MIL-P-14514G
INT. AMENDMENT 2(ME)
25 September 1991
SUPERSEDED
INT. AMENDMENT 1(ME)
10 may 1988

MILITARY SPECIFICATION

PUMPS, CENTRIFUGAL SELF-PRIMING,

FRAME MOUNTED 1-1/2-INCH, 65-GPM AX

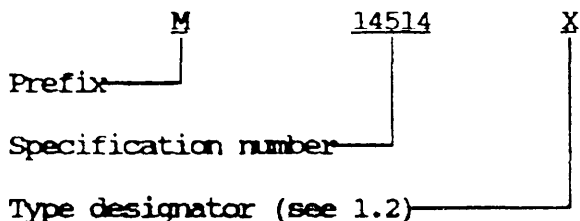
- * After 6.7, add the following new paragraph:

"6.8 Part or identifying number (PIN). The PIN to be used for pumping assemblies covered by this specification are designed as follows (see 3.16 and 6.2):

Example: M14514-II - A type II, diesel-engine-driven pumping assembly conforming to MIL-P-14514."

FIGURE 1. Accept-reject criteria.

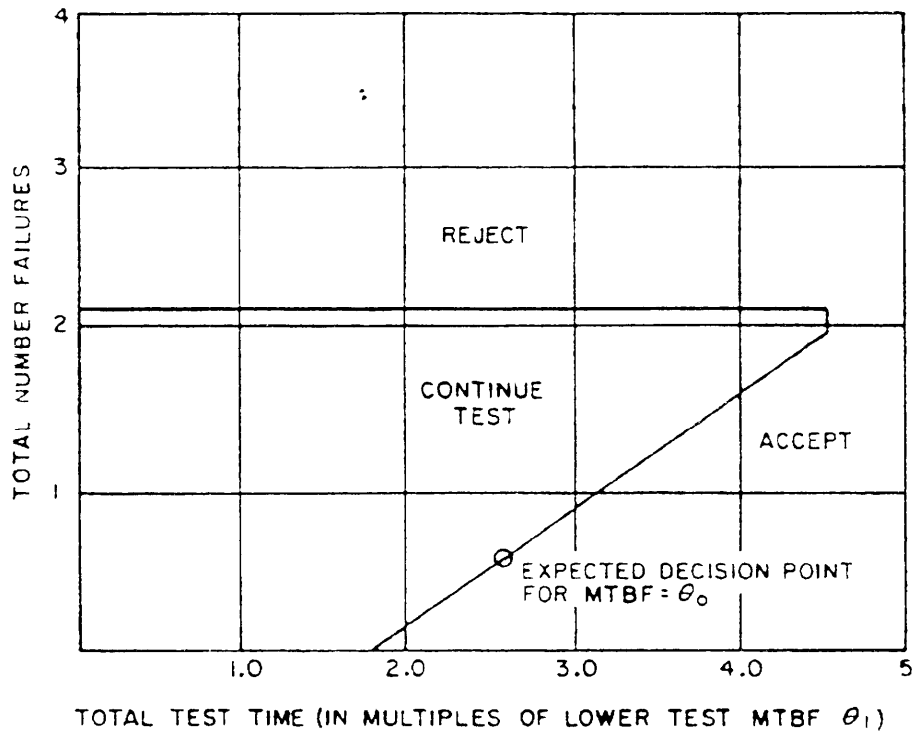
Delete figure 1 (X-3399) and substitute new figure 1 (X-4281A).
